SEAD-59 AND SEAD-71

PROJECT SCOPING PLAN FOR PERFORMING A CERCLA
REMEDIAL INVESTIGATION/FEASIBILITY STUDY (RI/FS) AT
THE FILL AREA WEST OF BUILDING 135 (SEAD-59), AND THE
ALLEGED PAINT DISPOSAL AREA (SEAD-71), SENECA ARMY
DEPOT ACTIVITY

APRIL 1997

**PROJECT SCOPING PLAN
REMEDIAL INVESTIGATION/FEASIBILITY STUDY
AT SEAD-59 and SEAD-71
SENECA ARMY DEPOT ACTIVITY
ROMULUS, NEW YORK**

**FIGURE 1-2
 SITE PLAN**

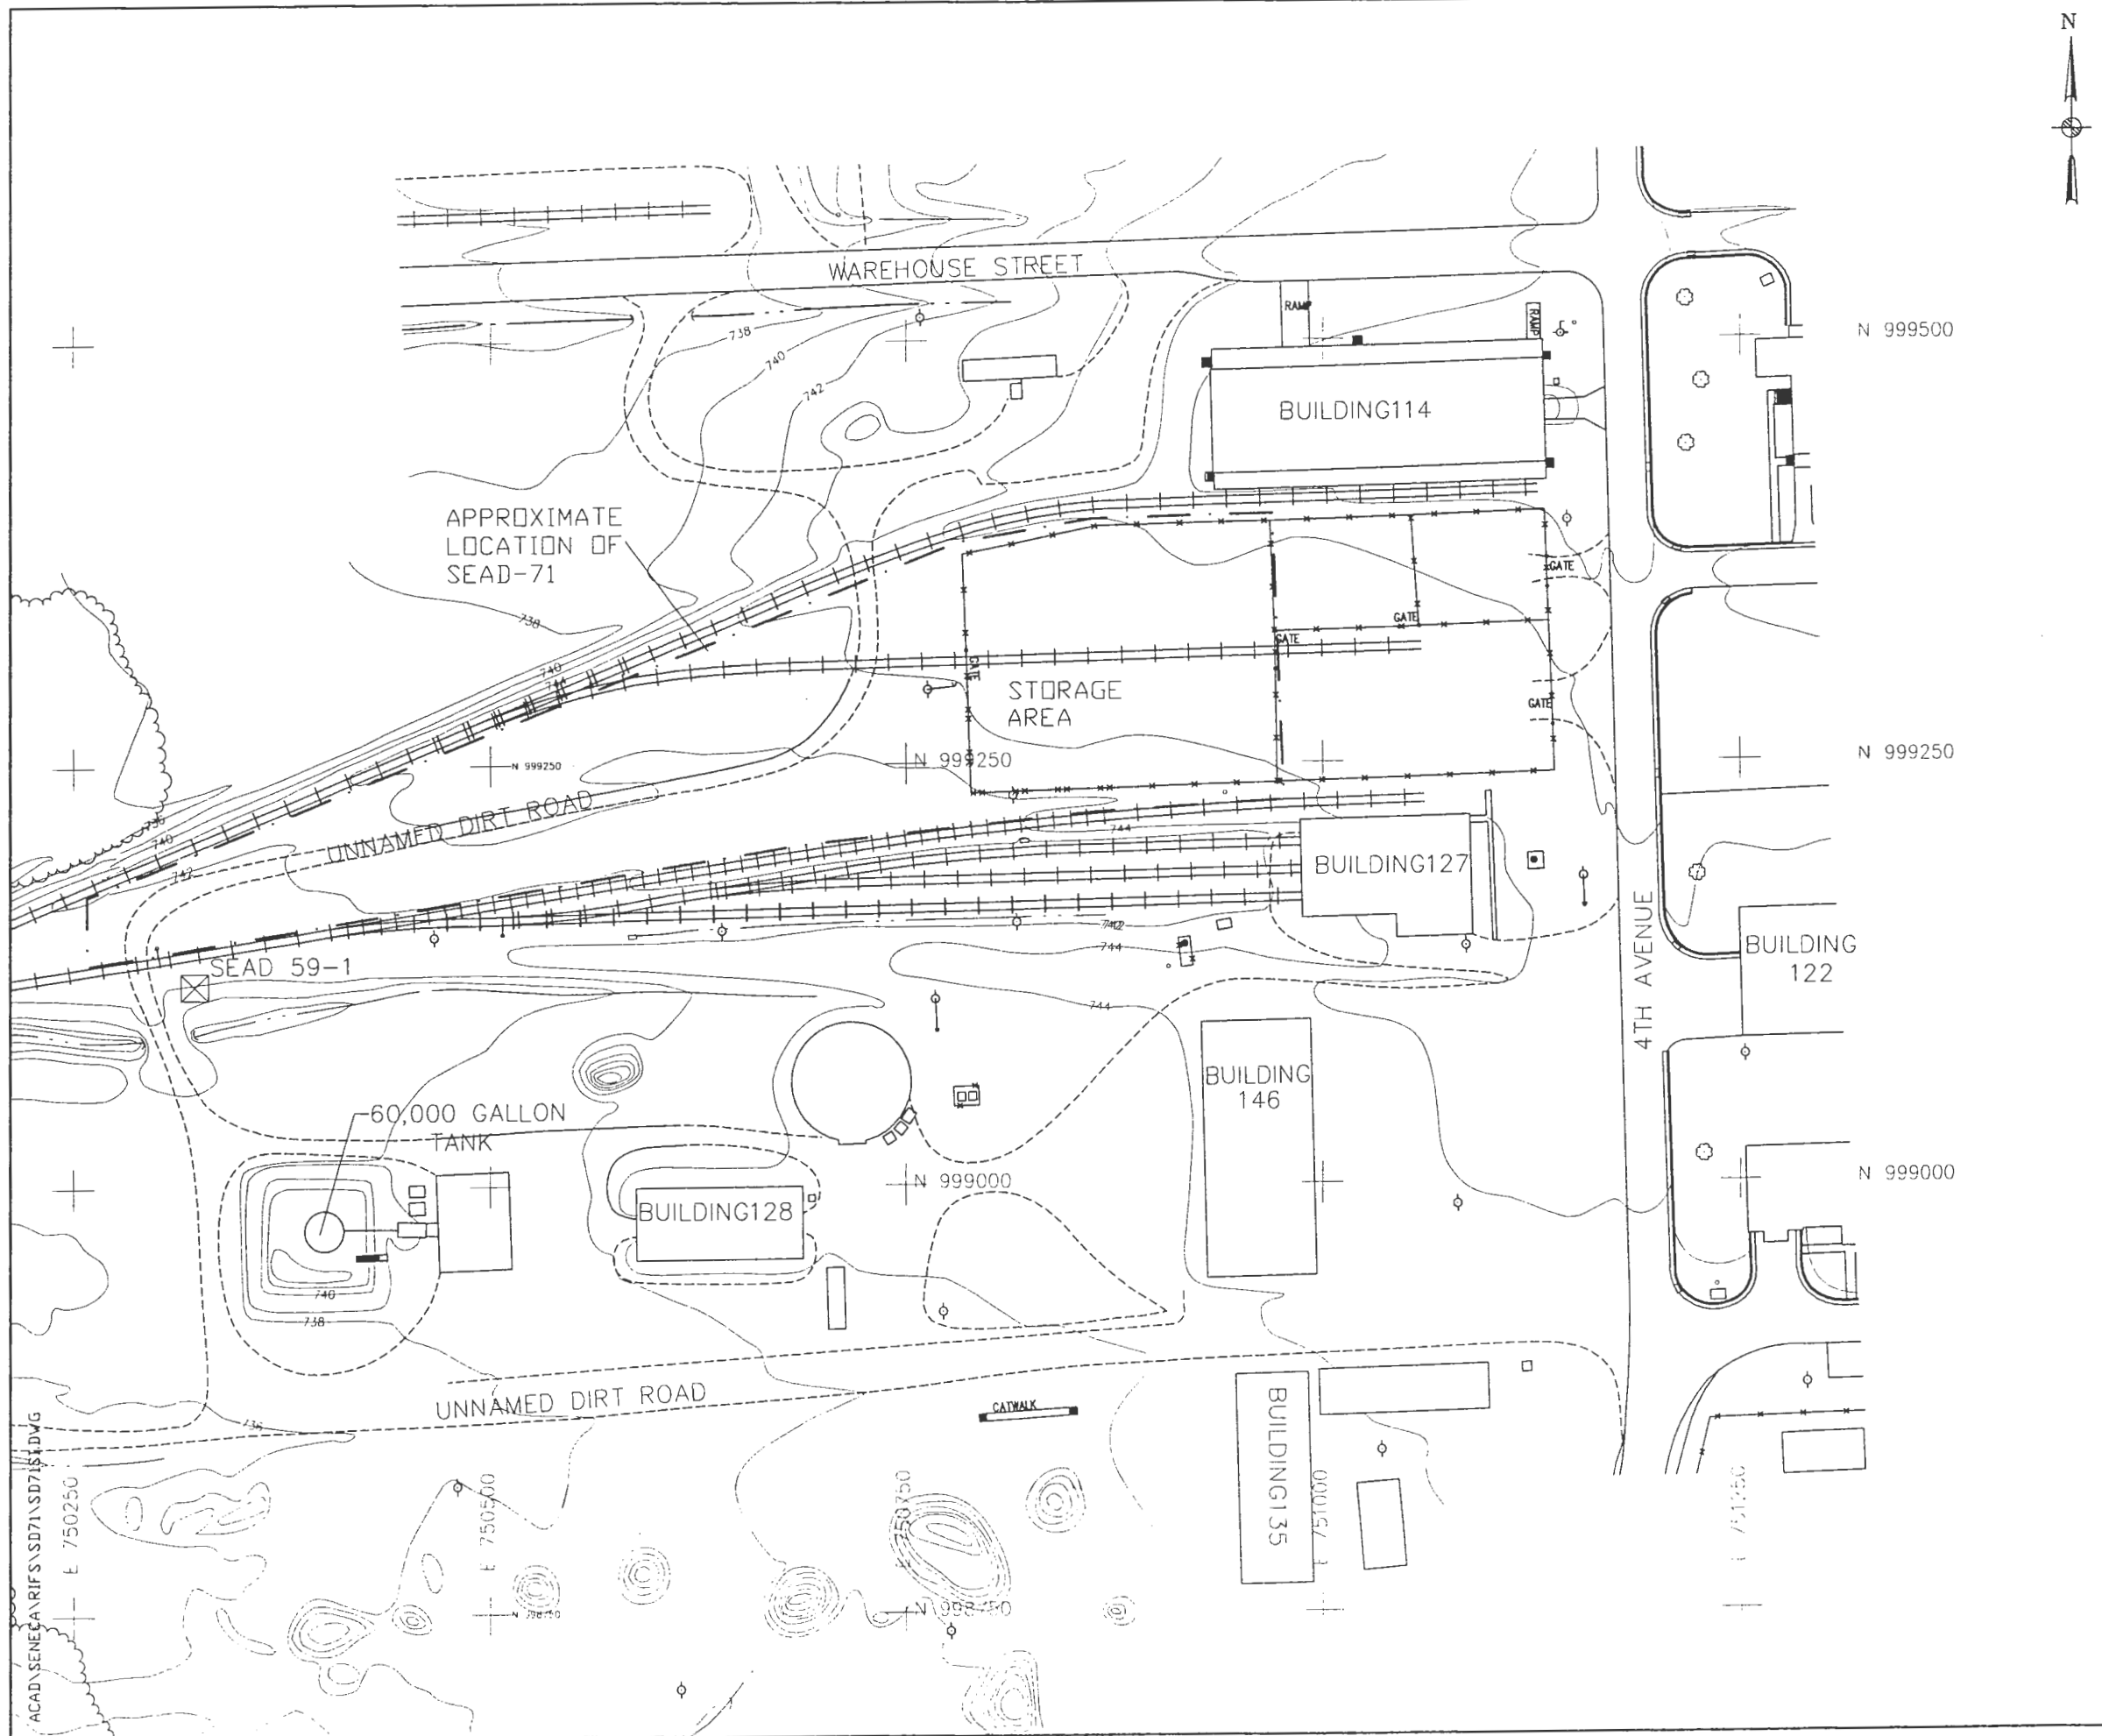
Comment #1 Figure 1-3: Based on the results of Test Pit TP59-1 (BTEX of 2,100,000 ug/kg) the area of the AOC delineated in Figure 1-3 should be expanded.

Response #1 Agreed. The extent of the area that defines SEAD-59 has been extended to the south as recommended in the comment. Figure 1-2 (formerly Figure 1-3) has been revised.

FIGURE 3-7
GROUNDWATER ELEVATION MAP

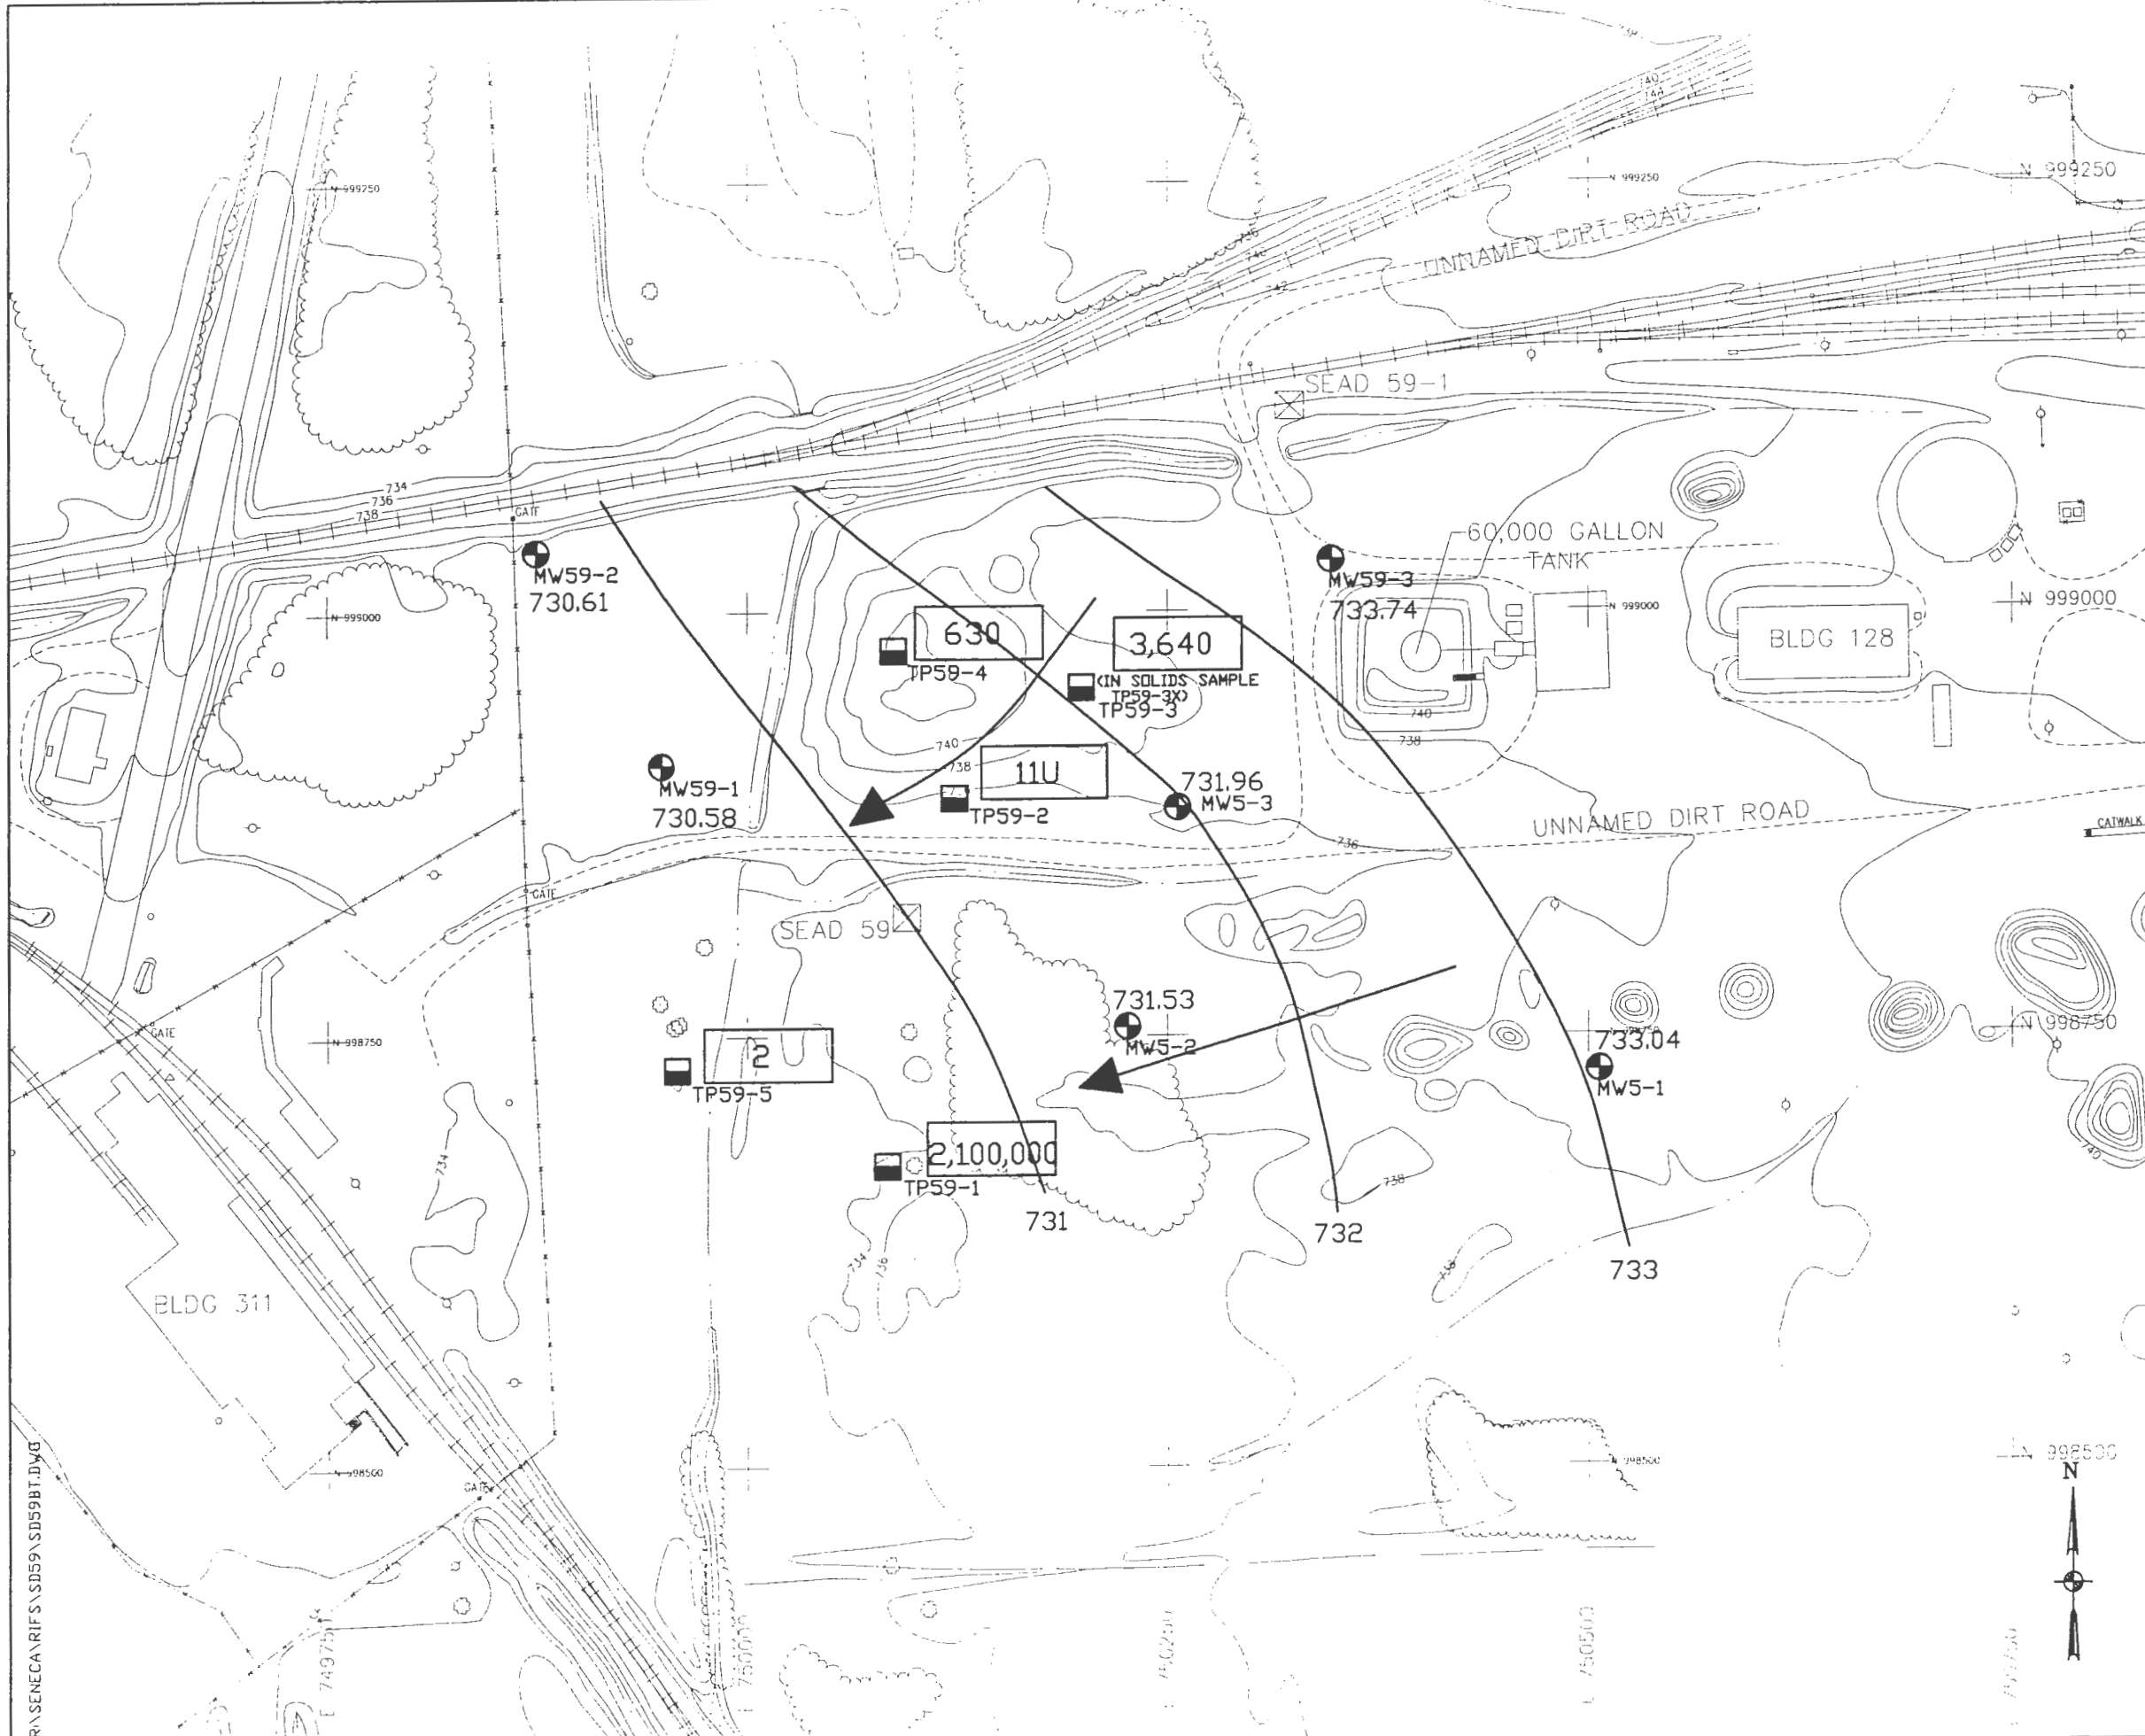
Comment #2 Figure 3-11: It is unclear what control was used to construct the 730 foot contour line presented on this figure. This same comment was made in the EPA's November 28, 1995 letter commenting on the Draft ESI Report for the Eight Moderately Low AOCs. In response to this comment the 730 foot contour was removed in the Draft Final version of this document.

Response #2 Agreed. The 730 foot contour was removed from Figure 3-7 (formerly Figure 3-11) as recommended in the comment.
